IREDELL COUNTY HEALTH DEPARTMENT

IMPROVEMENT PERMIT / AUTHORIZATION TO CONSTRUCT / OPERATION PERMIT / EXISTING SYSTEM INSPECTION

PERMIT# 095475 PIN# 4710-59-8325 DATE 10/8/01

SUBDIVISION River Hill Est BLOCK / SECTION LOT 8 LOT AREA 0.59 AC SITE CLASS PS DESIGN FLOW 360 L.T.A.R. 0.3

AS BUILT SKETCH

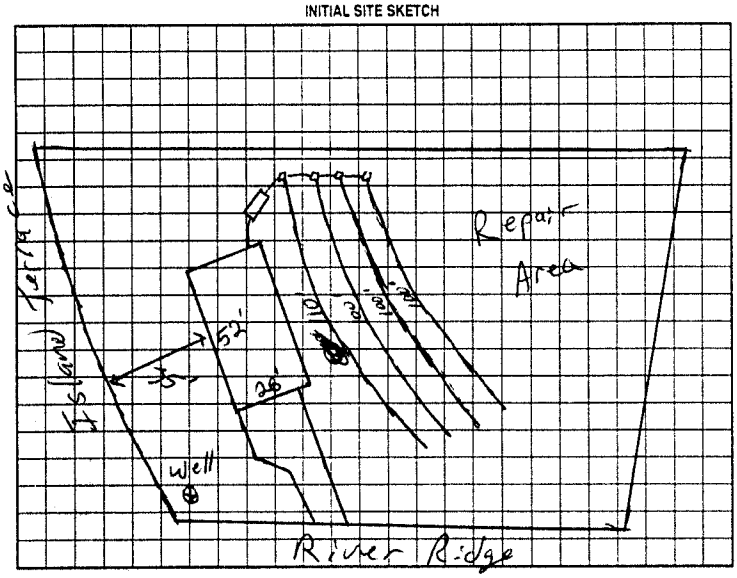
1st LINE = OK. MAY NEED TO CHANGE TO SHALLOW DROP BOX DEPENDING ON THE ONLY ditches changes

2nd LINE = NEEDS SHALLOW BOX, IT WILL BUST OUT OF GROUND IF DON'T. LINE HAS 4' OF HALL TRENCH BOTTOM & 5" FALL TOP OF PIPE, FIX IT BY ADDING ON TO CONC LINES the difference that not in compliance

3RD LINE = NEEDS SHALLOW DROP BOX

4th LINE = NEEDS CHECKING

BOXES LOWERED & 2nd DITCH FIXED, 3RD DITCH FINE, 4th DITCH FINE, EVERYTHING OK & 1st LINE HAS 10' EXTRA.

ELEVATION OF OUTLETS ON DROP BOXES PUSHED & WILL NOT BUST OUT OF GROUND UNLESS EXCESSIVE LANDSCAPING RESULTS (CUTTING).
